## DECLARATION OF DR. IVOR VAN HEERDEN

I. Review of the 2022 Joint Permit Application (JPA) dated 04/04/2022, CUP Permit Number P20220132.

## II. Comparison of Joint public Notice (PN) 2018 and Public Notice (PN) 2022.

Figure 1. Google Earth Image showing the very distinct difference in the widths of channels as marked.

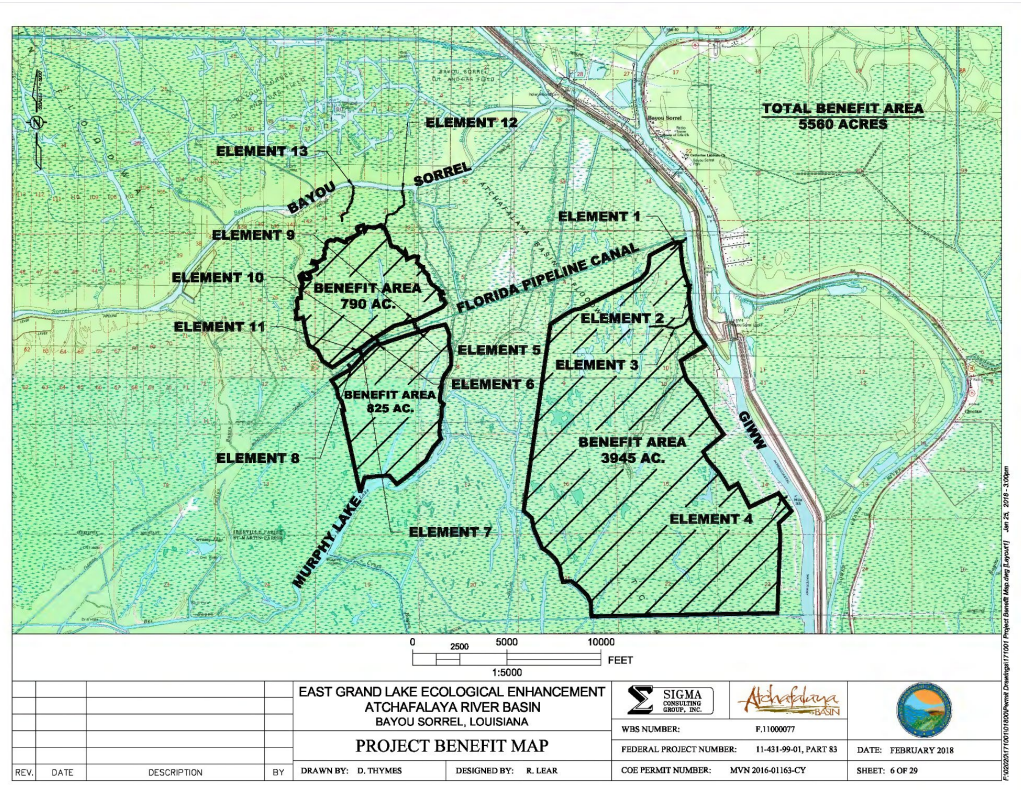
Review of a portion of the project area, depicted below in Figure 1, reveals that if you examine the width of the GIWW Channel, as it known, between where Bayou Sorrel and Grande River meet adjacent to the artificial Guide levee and the actual GIWW south (Section 1) and downstream of the Bayou Sorrel Locks (Section 2), the latter is more than twice the width. So going from a confined narrow channel to a much wider channel means that the flow will lose inertia (it slows down) and rapid sedimentation will take place. As stated above sediment falls out when the current slows. The USACE has thus created a ‘sediment trap’ immediately downstream of Bayou Sorrel that has to be dredged regularly at tax payers’ expense. Any project that enhances flows down Bayou Sorrel will exacerbate this problem.

Figure 2. Sheet 6 of 2018 JPA.

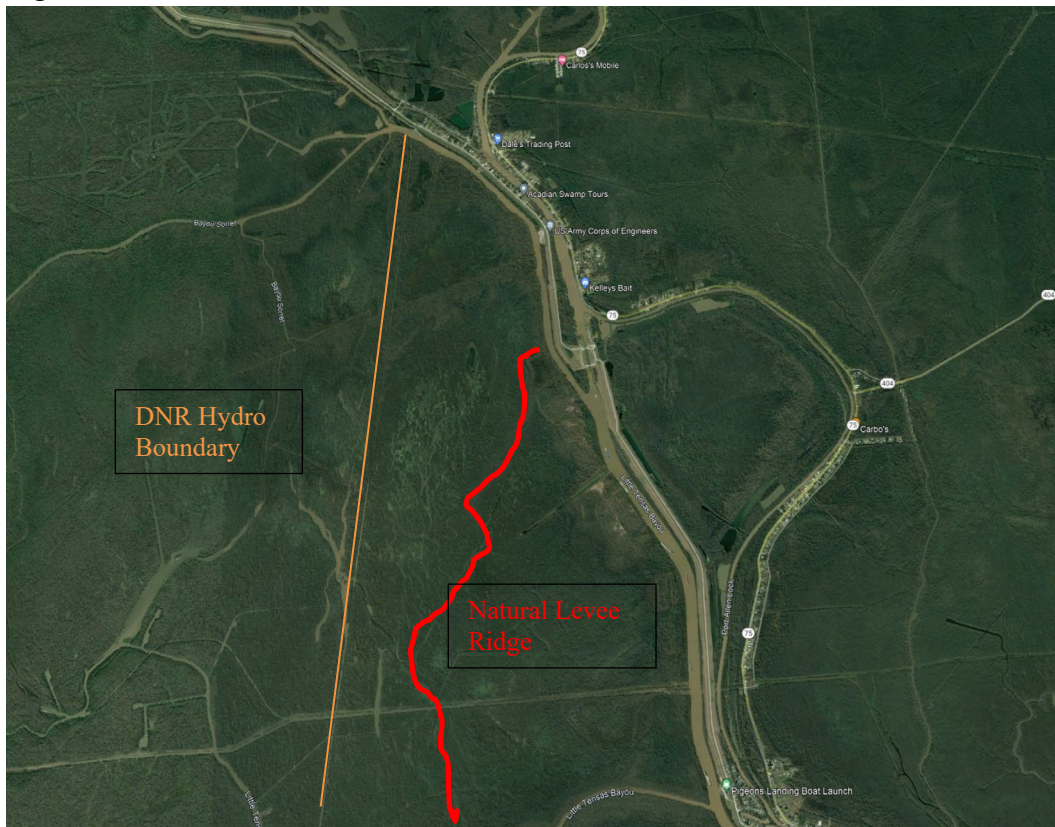
On the surface the PN (2022) has one less element but still claims the same area of benefit of 5560 acres; something is not right. Figure 2 is sheet 6 of the 2018 PN and reveals a claimed

substantial benefit area in the Vicinity of Element 4, which is missing from the 2022 PN. So, it would seem that the 2022 PN is claiming benefits well beyond the scope of the project given one less element. Missing from the 2022 PN is an image similar to Figure 2. Based on this analysis, it seems that the Corps or permittee has mistakenly inflated the benefit area since the project is “smaller” than the prior project and yet, proposes benefits outside the immediately adjacent area. (See Fig 2 Sheet 6 of 2018 JPN compared to claimed “benefit area” in 2022 JPN).

However, there is another error in this inflated benefit claim. As revealed in Figure 3 the area of benefit claimed for the Elements 1 through 4 in the 2018 PN do not fully consider the topography of the Basin and ignores the elevation difference (of mere centimeters) as well as flora. There is a very distinct and prominent former Bayou course running from Element 3 in a southerly direction all the way to beyond the project boundary (Red Trace on Figure 3). This natural levee would be a very effective hydrologic block to any flows that might make it down Elements 1, 2, and 3 into the Basin interior. Thus, the true area of so-called ‘benefit’ would be substantially less, by about 50% (Review figures 2 and 3 above). In this light all the claimed areas of benefit for this project need to be very carefully and scientifically assessed. Because the applicant has failed to provide modeled hydrologic data indicating that this ridge (former levee, or boundary identified above) would not impede the flow, the applicant has vastly overstated the benefit this project would produce. Indeed, more likely is that this levee would further “collect” additional sedimentation, causing the loss of high quality cypress wetlands and the formation of less ecologically desirable bottomland. This process has been described by van Heerden, 2019. Thus, the application is unreliable for the Corps review and should not be granted.
